Administrative Action
Preliminary Subdivision

Case File / Name: **S-94-07 Cheviot Assemblage**

SUBJECT: S-94-07 Cheviot Assemblage

OFFICIAL ACTION: **Approval with conditions**

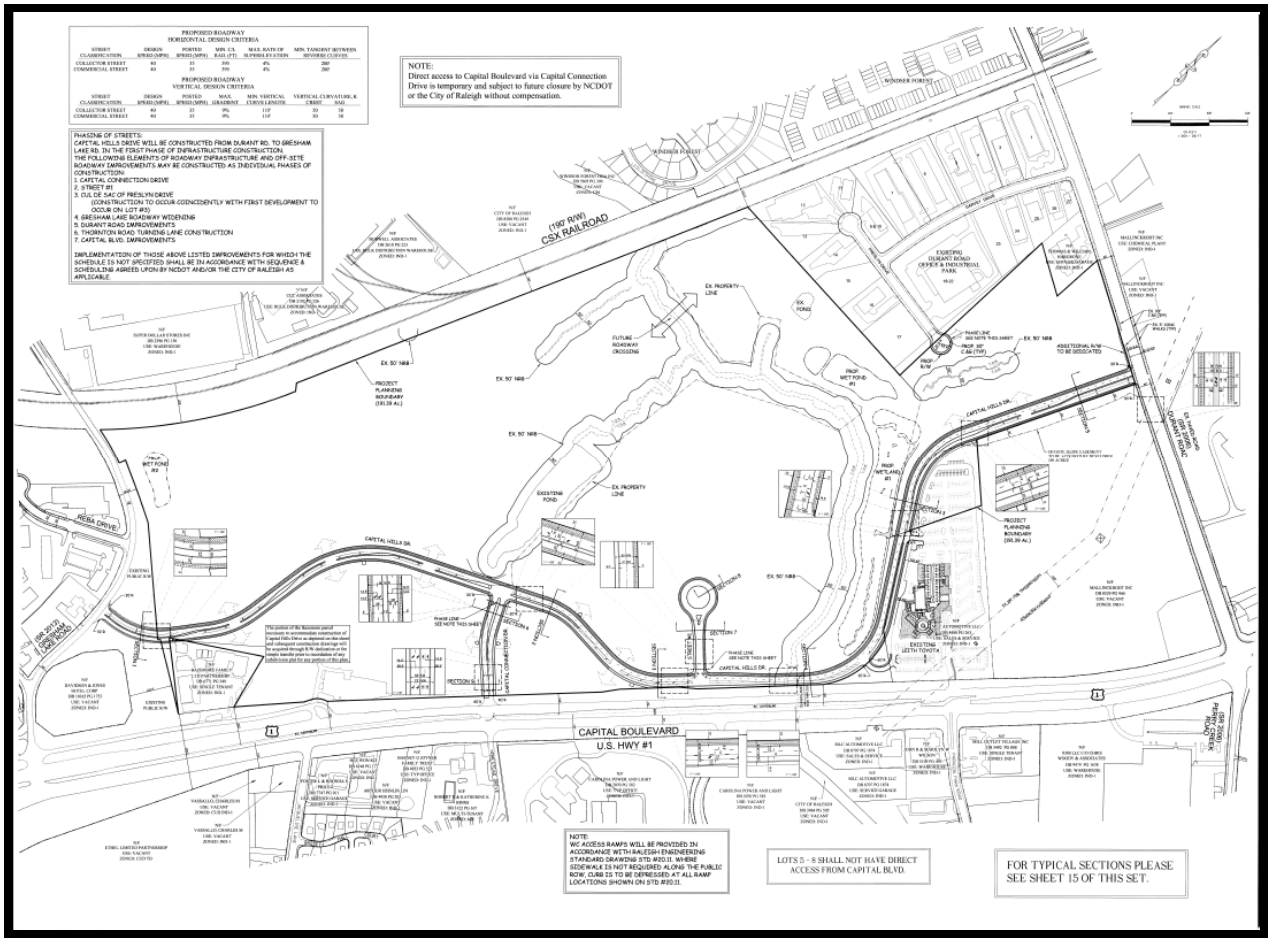
PROPOSED ROADWAY
HORIZONTAL DESIGN CRITERIA
PROPOSED ROADWAY
VERTICAL DESIGN CRITERIA
NOTE:
Direct access to Capital Boulevard via Capital Connection Drive is temporary and subject to future closure by NCDOT or the City of Raleigh without compensation.
PHASING OF STREETS:
CAPITAL HILLS DRIVE WILL BE CONSTRUCTED FROM DURANT RD. TO GRESHAM LAKE RD. IN THE FIRST PHASE OF INFRASTRUCTURE CONSTRUCTION.
THE FOLLOWING ELEMENTS OF ROADWAY INFRASTRUCTURE AND OFF-SITE ROADWAY IMPROVEMENTS MAY BE CONSTRUCTED AS INDIVIDUAL PHASES OF CONSTRUCTION:

1. CAPITAL CONNECTION DRIVE
2. STREET #1
3. CUL DE SAC OF PRESLYN DRIVE
(CONSTRUCTION TO OCCUR COINCIDENTLY WITH FIRST DEVELOPMENT TO OCCUR ON LOT #10)
4. GRESHAM LAKE ROADWAY WIDENING

5. DURANT ROAD IMPROVEMENTS
6. THORNTON ROAD TURNING LANE CONSTRUCTION
7. CAPITAL BLVD. IMPROVEMENTS
IMPLEMENTATION OF THOSE ABOVE LISTED IMPROVEMENTS FOR WHICH THE SCHEDULE IS NOT SPECIFIED SHALL BE IN ACCORDANCE WITH SEQUENCE & SCHEDULING AGREED UPON BY NCDOT AND/OR THE CITY OF RALEIGH AS APPLICABLE.
(180' R/W) CSX RAILROAD
WINDSOR FOREST
EXISTING DURANT ROAD OFFICE & INDUSTRIAL PARK
EX. 50' NRB
PROJECT PLANNING BOUNDARY (181.39 Ac.)
FUTURE ROADWAY CROSSING
EX. PROPERTY LINE
EXISTING POND
PROP. WET POND #1
PROP. WETLAND #1
CAPITAL HILLS DR.
REBA DRIVE
CAPITAL BOULEVARD
U.S. HWY #1
EXISTING LEITH TOYOTA
NOTE:
WC ACCESS RAMPS WILL BE PROVIDED IN ACCORDANCE WITH RALEIGH ENGINEERING STANDARD DRAWING STD. #120.11. WHERE SIDEWALK IS NOT REQUIRED ALONG THE PUBLIC ROW, CURB IS TO BE DEPRESSED AT ALL RAMP LOCATIONS SHOWN ON STD #120.11.
LOTS 5 - 8 SHALL NOT HAVE DIRECT ACCESS FROM CAPITAL BLVD.
FOR TYPICAL SECTIONS PLEASE SEE SHEET 15 OF THIS SET.
